LAND PROTECTION DIVISION DEPARTMENT OF ENVIRONMENTAL QUALITY

RE: Permit Renewal Application for Class I Non-Hazardous UIC Well

UIC Permit No. IW-NH-49022-R1 Response to ODEQ Notice of Deficiency

Figure 1 Area Of Review (AOR) and faults from Huffman (1958), Darold and Holland (2015)

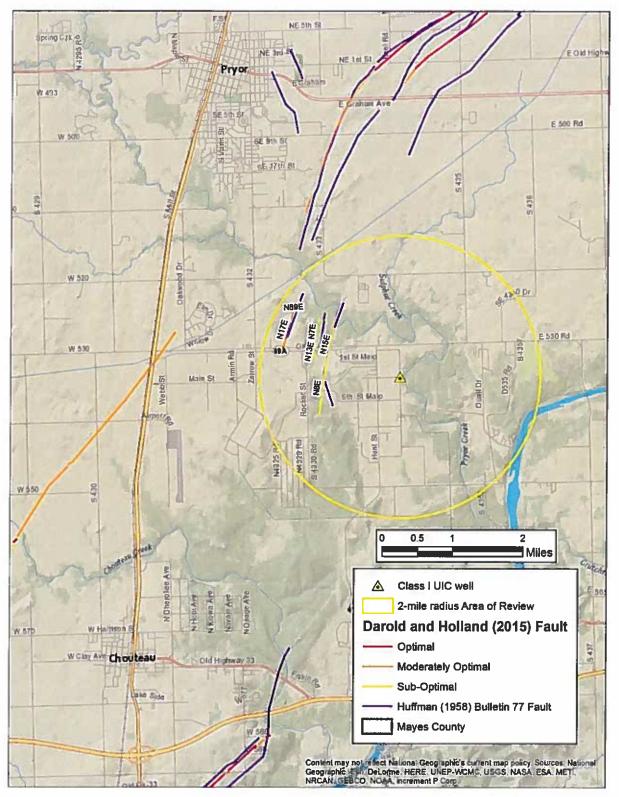
Item 9: Oklahoma Geological Survey (OGS) Bulletin 77 identifies several faults located about one mile west of the injection well that are in optimal orientation for potential earthquake

occurrences (N\35E to N150E) per Dr. Murray's letter in APPENDIX F-l. In this orientation, they are not self-sealing and would potentially represent earthquake locales or pathways for injectate migration out of the injection zone. The other nearby faults to the northwest are deemed self-sealing due to their orientation and may represent barriers or boundaries to injectate flow. PCC addressed this concern in the April 8, 2014 response to the Five Year Review with anecdotal data and volunteered to do additional review and demonstration. Please provide an analysis of what effects these faults would have on plume movement, since the model did not consider them as consequential assuming them to be minor surface faults.

Response: The Huffman (1958) Bulletin 77 has since been updated by The Darold and Holland (2015) and Marsh and Holland (2016) maps and GIS databases. These updated publications include most fault segments from the Huffman (1958) Bulletin 77. The faults presented in Dr. Murray's letter in APPENDIX F-1 were based on the more recent Darold and Holland (2015) maps and GIS database rather than the Huffman (1958) Bulletin 77, which is sixty years old. As shown on Figure 1, attached, the six fault segments within the AOR mapped by Darold and Holland (2015) are sub-optimal (N7E, N8E, N13E, and N15E, and N89E) or moderately optimal (N17E) in their orientation relative to the contemporary stress field (N85E). In other words, because the faults are not optimally oriented, they are not prone to slip because of minor perturbations in the stress field or subsurface pressures, and the faults generally "have a low likelihood to have an earthquake." (Darold and Holland, 2015). In addition, we note that that slip potential is based on orientation and seismic history. An examination of the seismic history of Mayes County confirms virtually no seismic activity. As a result, the orientation and seismic history demonstrates that there is almost no seismic hazard risk in the region near the well.

At the time that the Huffman (1958) Bulletin 77 was published, only faults that were mappable or seen at the surface could be interpreted, so the vertical extents of the faults are unknown (e.g., hydraulic connection of the Arbuckle to near surface rocks or aquifers is unknown). Five (N7E, N8E, N13E, N15E, and N17E) of the six fault segments in the AOR would be undergoing compressional stresses because they are nearly perpendicular (at 68-78 angles) to the N85E contemporary stress field. The remaining one fault (N89E) would be experiencing shear stresses from the nearly parallel N85E contemporary stress field. However, compressional or shear stresses from the contemporary N85E stress field are not the sole indicators of a "self-sealing" or "transmissive" faults/fractures. Geologic conditions and history such as deposition and overburden development, uplift, karstification, and re-mineralization must also be examined to define the hydraulic characteristics of a fault or fracture zone. However, because the Arbuckle SWD zone has artesian pressure in Mayes County, there is no apparent natural hydraulic connection between the Arbuckle and overlying sedimentary units. If there were a hydraulic connection between the Arbuckle and overlying sedimentary units, the artesian pressure would have equilibrated to hydrostatic pressure over geologic time. The current artesian condition of the Arbuckle is a good indicator that faults and fractures in the region are not pathways for vertical fluid migration, but rather are barriers to fluid flow.
